101 GRADING & PLOT PLAN

PLOT PLAN & DETAILS FOR HANGAR-OFFICE BUILDING
ADDISON AIRPORT, ADDISON, TEXAS

The Town of Addison has reviewed your building plans and issued a building permit with the understanding that the items checked below, as well as noted elsewhere on the plans, are to be complied with or corrected. The items checked on this list were either shown incorrectly on the plans or were not shown in sufficient detail on the plans. Unless otherwise noted, all questions should be directed to the Building Inspection Department.

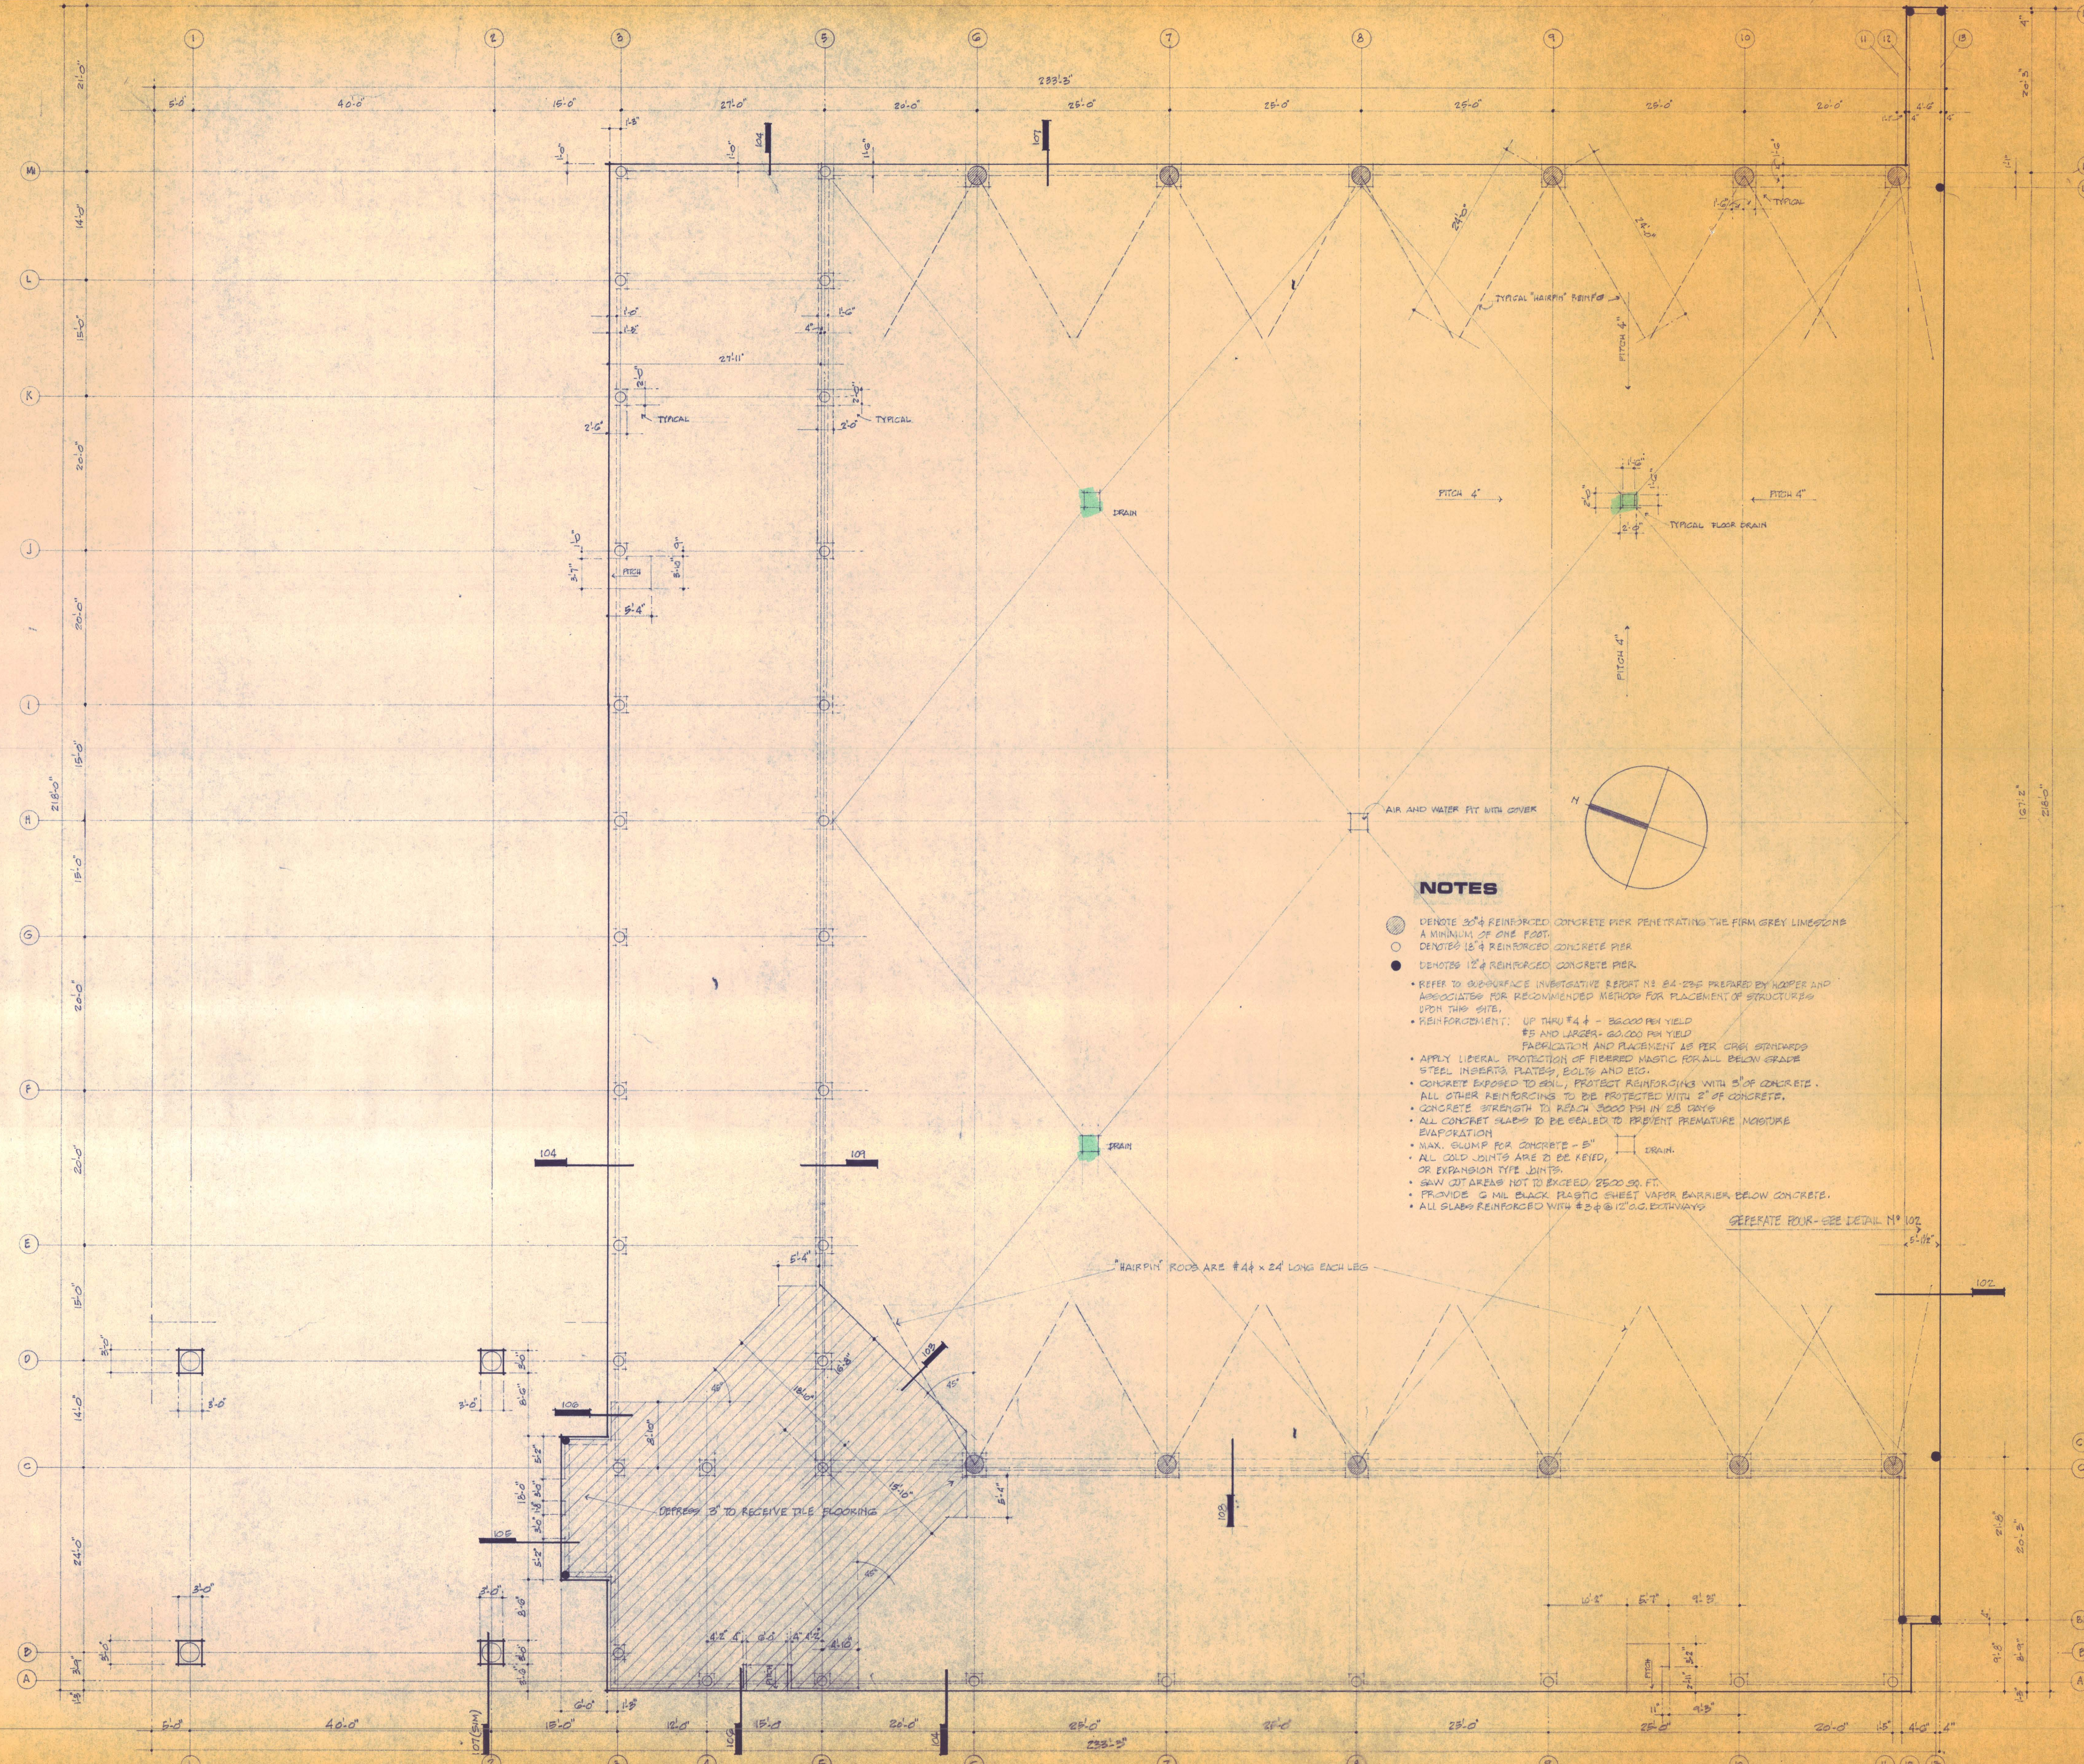
• SPRINKLER PLANS & CALCULATIONS TO BE SUBMITTED TO FIRE DEPT.
• FIRE HYDRANT REQUIRED (CONTACT FIRE DEPT.)
• NOTE SHEET #3 AREA

FIRST FLOOR PLAN
FOR HANGAR-OFFICE BUILDING
ADDISON AIRPORT, ADDISON, TEXAS

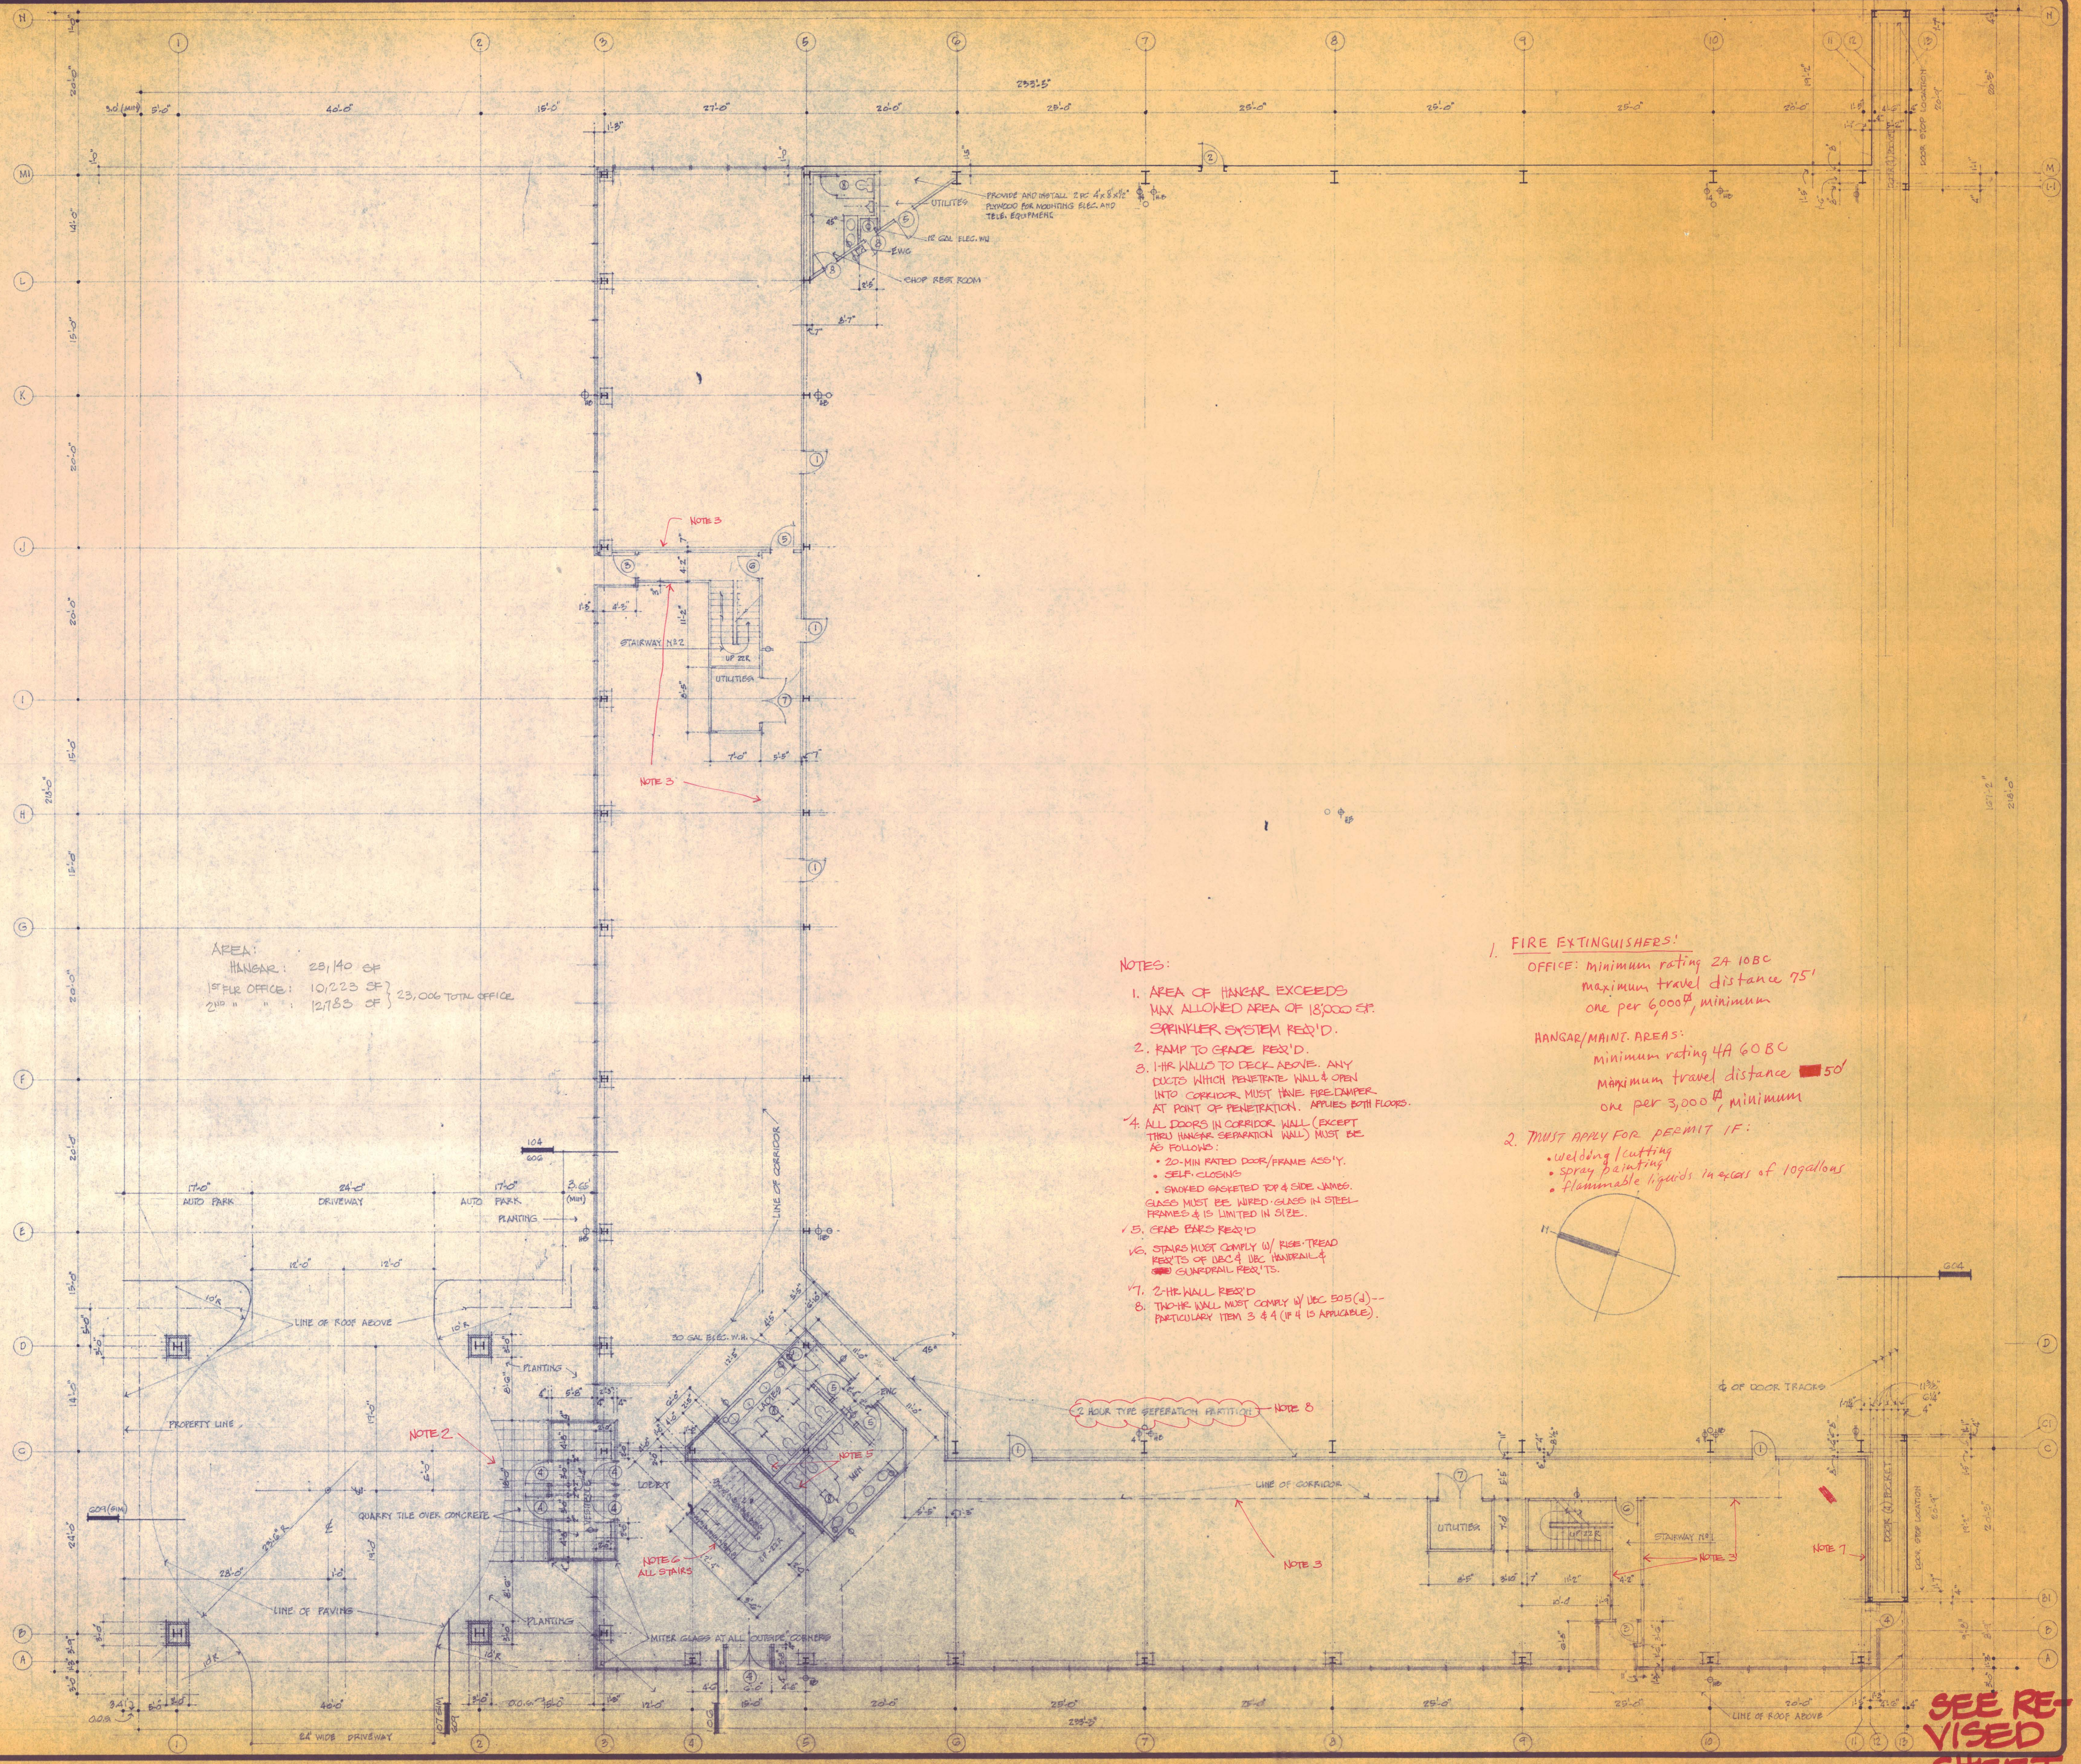
1. AREA OF HANGAR EXCEEDS MAX ALLOWED AREA OF 18,000 SF. SPRINKLER SYSTEM REQ'D.
2. RAMP TO GRADE REQ'D.
3. 1 HR WALLS TO DECK ABOVE. ANY DUCTS WHICH PENETRATE WALL & OPEN INTO CORRIDOR MUST HAVE FIRE DAMPER AT POINT OF PENETRATION. APPLIES BOTH FLOORS.
4. ALL DOORS IN CORRIDOR WALL (EXCEPT THRU HANGAR SEPARATION WALL) MUST BE AS FOLLOWS:
 - 20-MIN RATED DOOR/FRAME ASS'Y.
 - SELF-CLOSING
 - SMOKE GASKETED TOP & SIDE JAMES.
 - GLASS MUST BE WIRE GLASS IN STEEL FRAMES & IS LIMITED IN SIZE.
5. GRAB BARS REQ'D
6. STAIRS MUST COMPLY W/ RISE-TREAD REQS OF DEC 4 DEC HANDRAIL & COUNDRAIL REQS.
7. 2-HR WALL REQ'D
8. THRU-WALL MUST COMPLY W/ DEC 505(d) - PARTICULARLY ITEM 3 & 4 (IF 4 IS APPLICABLE).

1. FIRE EXTINGUISHERS!

OFFICE: minimum rating 2A 10BC
 maximum travel distance 75'
 one per 6,000^{sq} ft, minimum

HANGAR/MAINT. AREAS:
 minimum rating 4A 60BC
 maximum travel distance 50'
 one per 3,000^{sq} ft, minimum

2. MUST APPLY FOR PERMIT IF:

- welding/cutting
- spray painting
- flammable liquids in excess of 10 gallons
